Access Compliance Report

Public Rights-of-Way

(Curb Ramps)

Intersection ID: 26112	Main Street: COLONIAL HEIGHTS DR	Cross Street: ELM LN	Location: SW
ADA ID: C9CE953720F1	Ramp Type: Perp	Initial Pass/Fail: Fail	Overall Compliance: No
Severity Score: 22.5			
Codes/Mitigation Info/Possible Solution		Field Measurements/Component Compliance

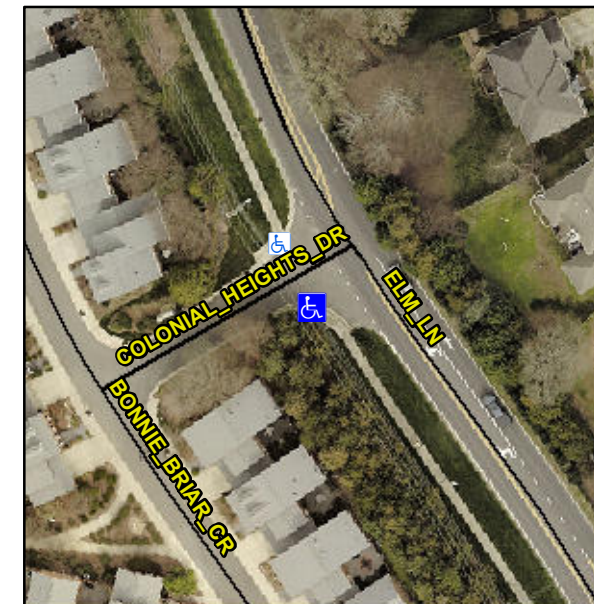
R304.5.1, R304.2.2, R304.5.3

Compliance	Description	Data	Compliance	Description	Data
N/A	Ramp Length (in)	59.0	No	Ramp Slope (%)	9.1
No	Ramp Width (in)	39.0	No	Ramp XSlope (%)	2.5
N/A	Flare Type LT	N/A	N/A	Flare Type RT	N/A
N/A	Flare Slope LT (%)	N/A	N/A	Flare Slope RT (%)	N/A
N/A	Flare Traversable LT?	N/A	N/A	Flare Traversable RT?	N/A
N/A	Landing Length (in)	N/A	N/A	DWS Provided?	N/A
N/A	Landing Width (in)	N/A	N/A	DWS Contrast?	N/A
N/A	Landing Slope (%)	N/A	N/A	DWS Length (in)	N/A
N/A	Landing X Slope (%)	N/A	N/A	DWS Full Width?	N/A
N/A	Landing Curb? (Y/N)	N/A	N/A	DWS Offset (in)	N/A
N/A	Shared Landing?	N/A			
N/A	Gutter Ponding?	N/A	N/A	Gutter Slope (%)	N/A
N/A	Gutter Lip Ht (in)	N/A	N/A	Gutter X Slope (%)	N/A
N/A	Painted X Walk1?	No	N/A	Painted X Walk2?	N/A
	X Walk 1 Direction	To N		X Walk 2 Direction	N/A
N/A	X Walk 1 Width (in)	N/A	N/A	X Walk 2 Width (in)	N/A
	X Walk 1 Slope (%)	2.0		X Walk 2 Slope (%)	N/A
	X Walk 1 X Slope (%)	2.4		X Walk 2 X Slope (%)	N/A

N/A	Ramp inside XWalk1?	N/A	N/A	Ramp inside XWalk2?	N/A
	Road Slope (%)	N/A	N/A	Clear Space?	N/A
	Road X Slope (%)	N/A	N/A	Clear Space to XWalk (in)	N/A
N/A	Any Obstructions?	N/A	N/A	Storm Grate/Utility Hazard?	N/A
	Obstruction Type			Storm Grate/Utility Type	
		N/A			N/A
			Yes	Surface Condition? (G/P)	Good

Remove & Replace Entire Ramp.
